Access Compliance Report

Public Rights-of-Way

Intersection ID: 45282	Main Street: ARWEN_RD	Cross Street: VALLEY_RIDGE_RD	Location: S
ADA ID: AABD5EE999C0	Ramp Type: PerpDiag	Initial Pass/Fail: Fail	Overall Compliance: No
		Severity Score: 47.5

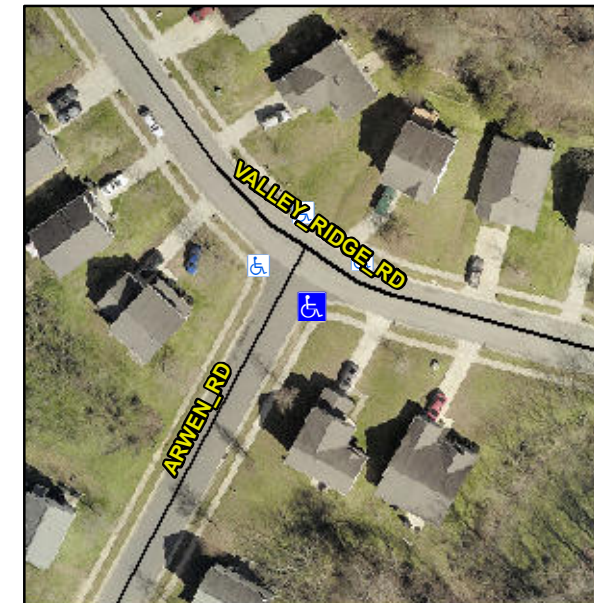
Not Found, R304.5.1, R304.5.3

Compliance	Description	Data	Compliance	Description	Data
N/A	Ramp Length (in)	49.0	Yes	Ramp Slope (%)	7.0
No	Ramp Width (in)	26.0	No	Ramp XSlope (%)	5.2
N/A	Flare Type LT	N/A	N/A	Flare Type RT	N/A
N/A	Flare Slope LT (%)	N/A	N/A	Flare Slope RT (%)	N/A
N/A	Flare Traversable LT?	N/A	N/A	Flare Traversable RT?	N/A
N/A	Landing Length (in)	N/A	N/A	DWS Provided?	N/A
N/A	Landing Width (in)	N/A	N/A	DWS Contrast?	N/A
N/A	Landing Slope (%)	N/A	N/A	DWS Length (in)	N/A
N/A	Landing X Slope (%)	N/A	N/A	DWS Full Width?	N/A
N/A	Landing Curb? (Y/N)	N/A	N/A	DWS Offset (in)	N/A
N/A	Shared Landing?	N/A			
N/A	Gutter Ponding?	N/A	N/A	Gutter Slope (%)	N/A
N/A	Gutter Lip Ht (in)	N/A	N/A	Gutter X Slope (%)	N/A
N/A	Painted X Walk1?	No	N/A	Painted X Walk2?	No
	X Walk 1 Direction	To NE		X Walk 2 Direction	To NW
N/A	X Walk 1 Width (in)	N/A	N/A	X Walk 2 Width (in)	N/A
	X Walk 1 Slope (%)	4.2		X Walk 2 Slope (%)	6.7
	X Walk 1 X Slope (%)	6.6		X Walk 2 X Slope (%)	1.2

Remove & Replace Curb Ramp With Two New Directional Ramps or Equivalent.
